SUBJ: Cedar Hill Road Subdivision (1512-1524 Cedar Hill)-#25-07SUBD

Reference: 1512 & 1524 Cedar Hill Road Subdivision
TMP's #39-00-00646-00-8 and #39-00-00649-00-5
Preliminary/Final Land Development Application

Pursuant to your request, Gilmore & Associates, Inc. performed a review of the preliminary submission for land development for the above-referenced project. Upon review, we offer the following comments for consideration by the Lower Gwynedd Township Board of Supervisors:

GRAPHIC SCALE

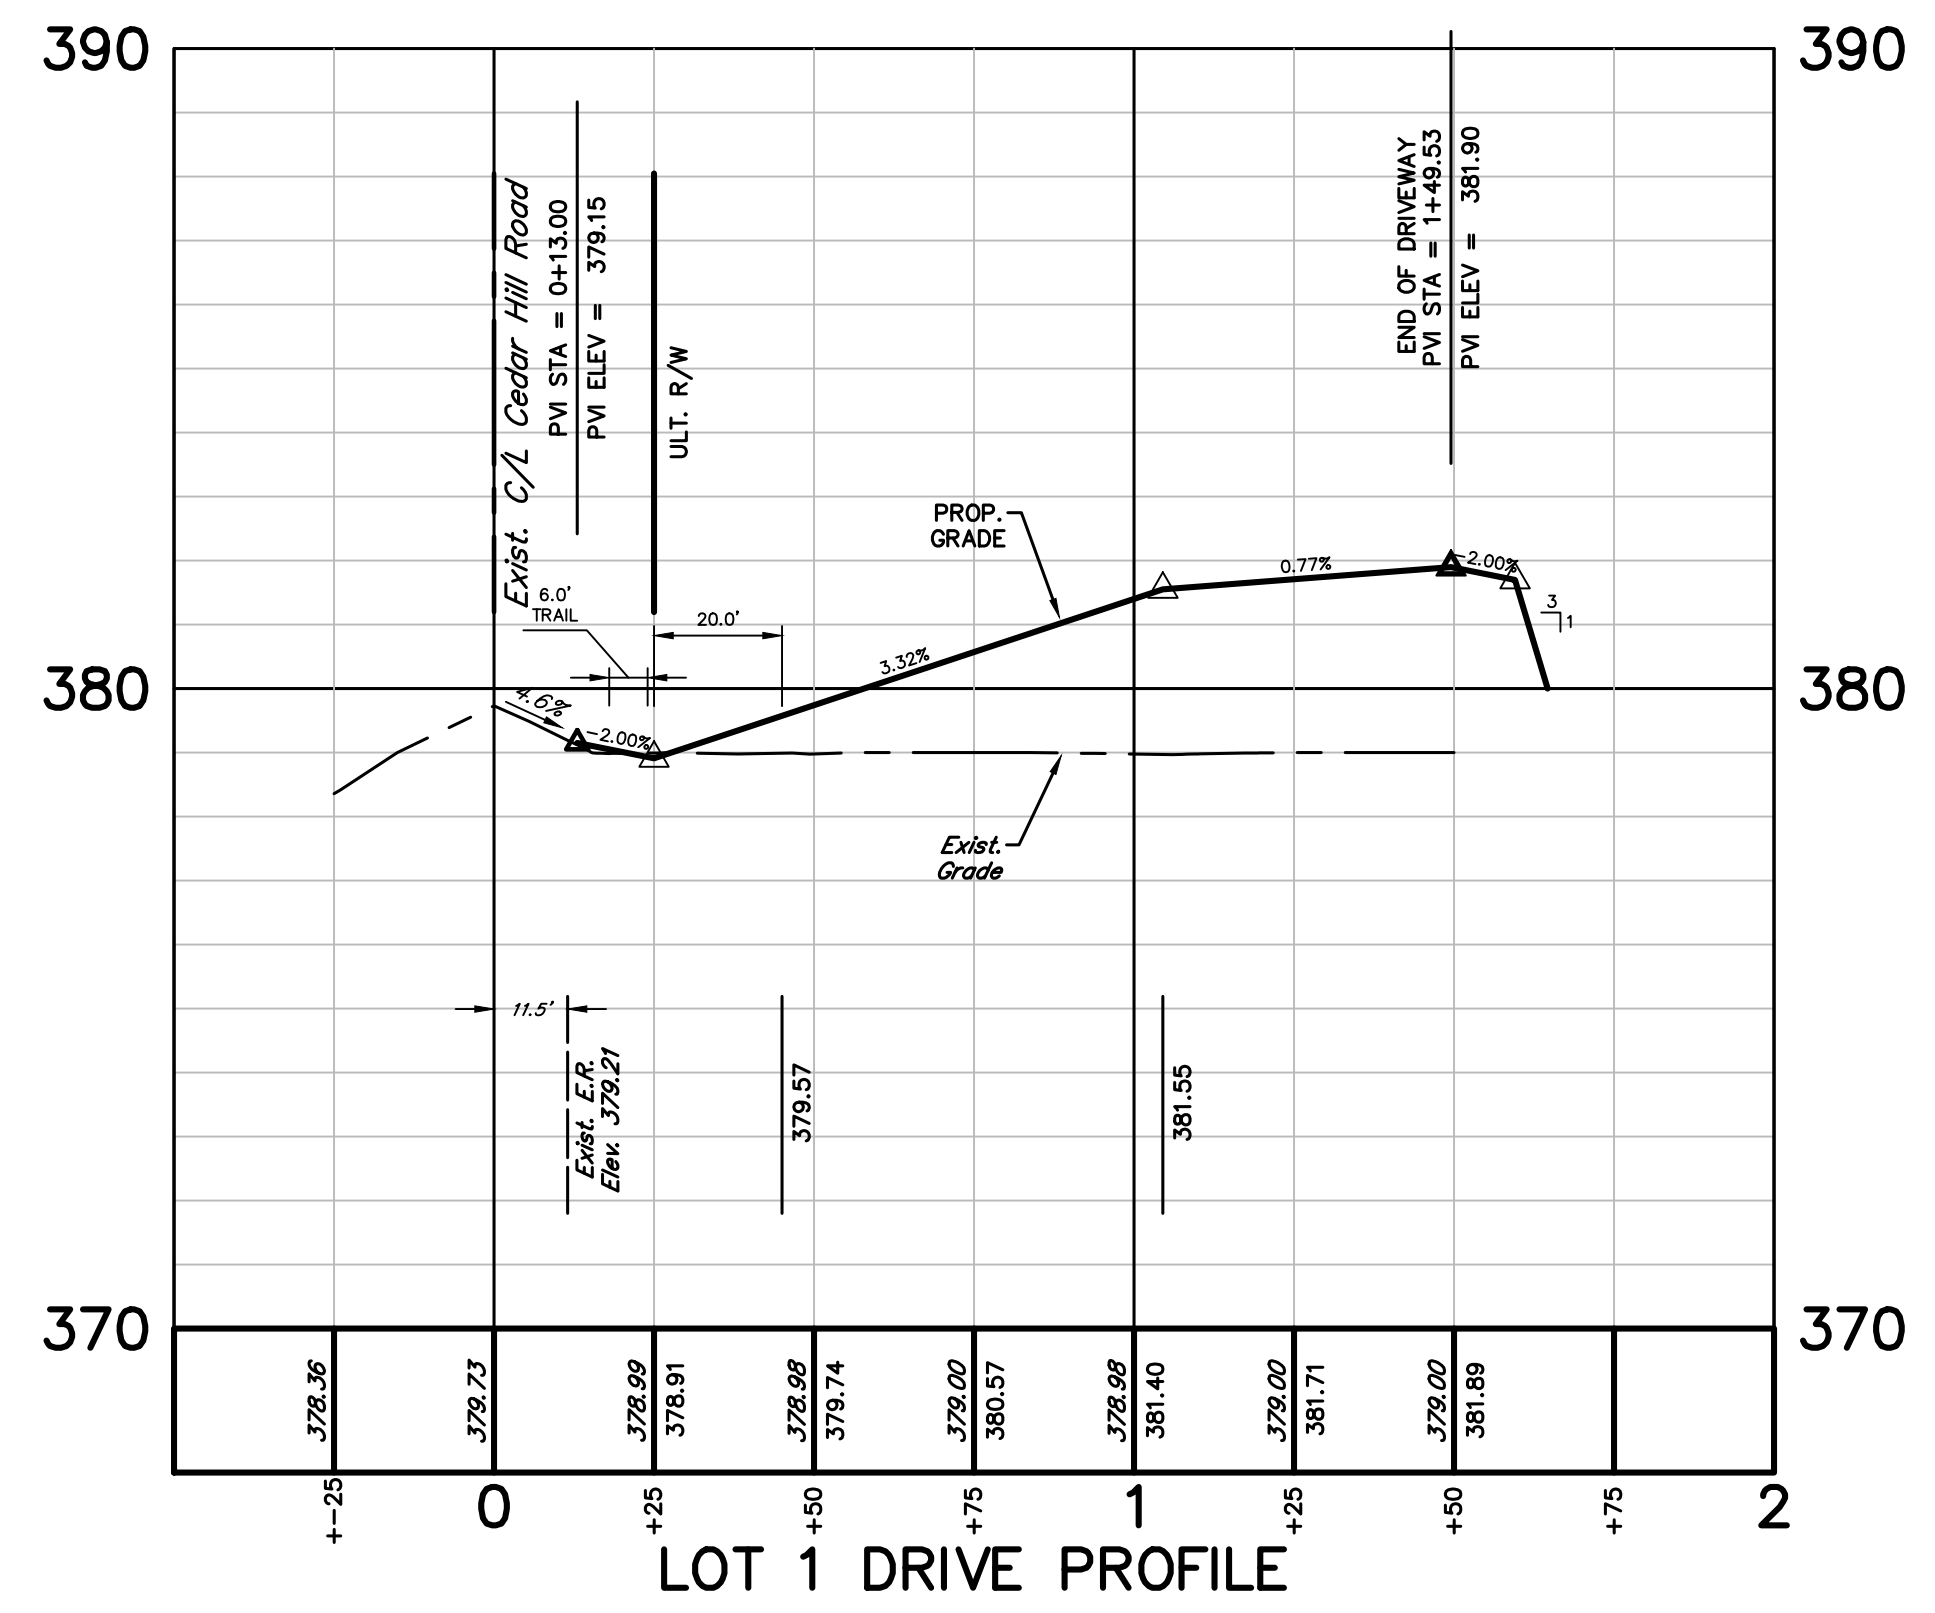
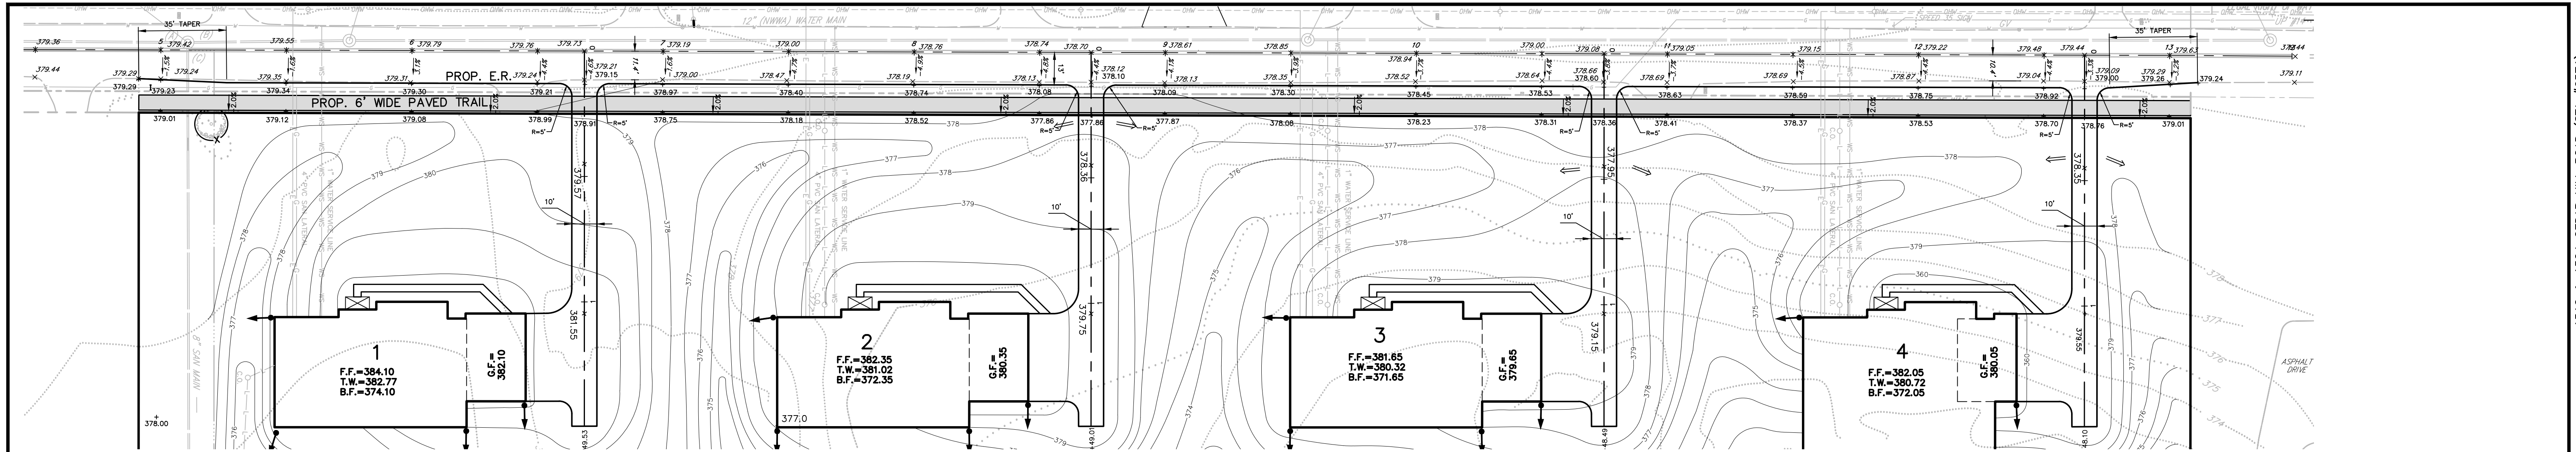
5. The details provided on Sheet 14 of the plan set appear to have a discrepancy in regards to the grass strip width between the edge of pavement and the proposed paved trail. The designer should evaluate and revise as necessary, and the buffer strip should be in accordance with **Section 1230-45** of the **Subdivision and Land Development Ordinance**.

Response: The details on Sheet 14 have been corrected to be consistent and now show a 5 ft. wide grass strip which exceeds the minimum required 4 ft. grass strip in §1230-45.
